SCALE: DRAWN BY: BOX BEAM DETAILS PHIL JOB NAME: ITEM 515 REVISED: BRIDGE NO. LOG - 113 - 1.73 LOGAN COUNTY PROJECT NO. C.R. 113 DATE: APPROVED BY: DRAWING NO. E.O.C. JANUARY 2007 1 OF 3

TYPICAL FASCIA BEAM BRIDGE NO. LOG - 113 - 1.73 ITEM 515 LOGAN COUNTY PROJECT NO. C.R. 113 UNITED PRECAST INC. ROUNDHOUSE LANE **SCALE** PHIL MT. VERNON, OHIO 43050 REVISED -----PHONE:(740)393-1121, FAX:(740)393-0044 DATE APPROVED BY: DRAWING NO. 2/1/07 E.O.C. JAN. 2007 3 OF 3

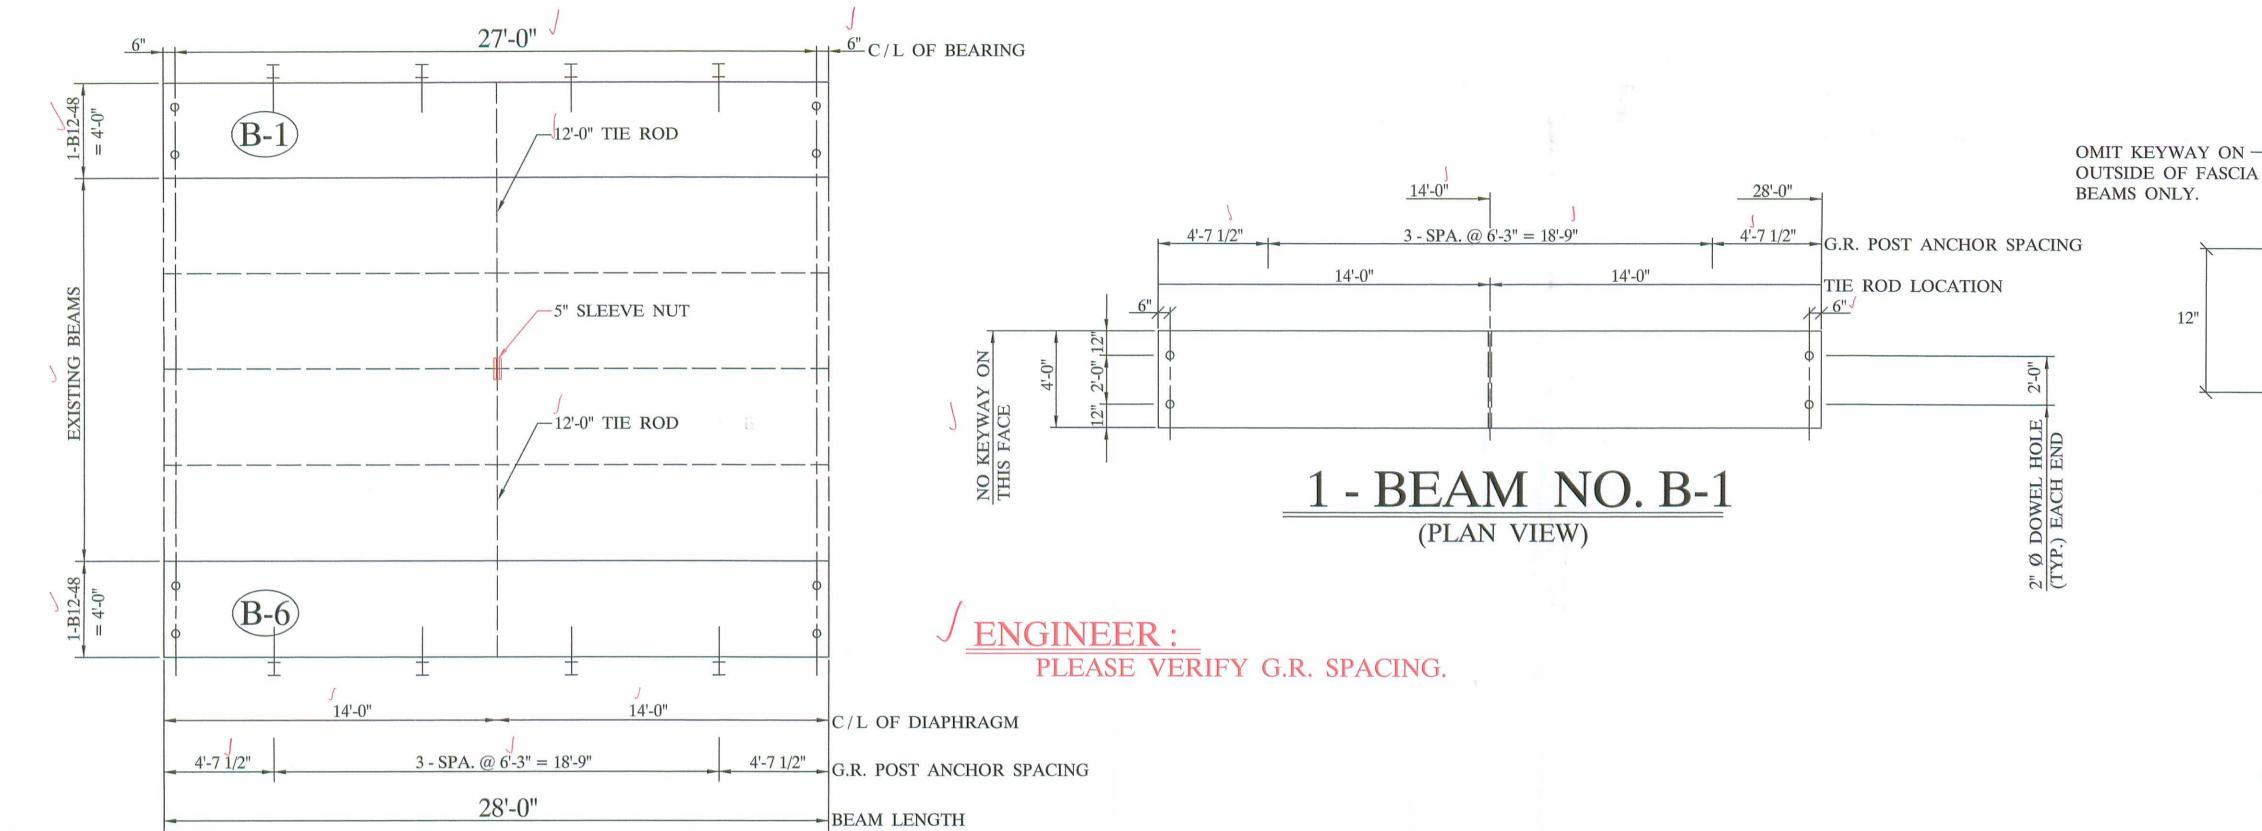
ENGINEER: PLEASE VERIFY

CONTRACT DRAWINGS CALL

FOR #5, ODOT STD. #4?
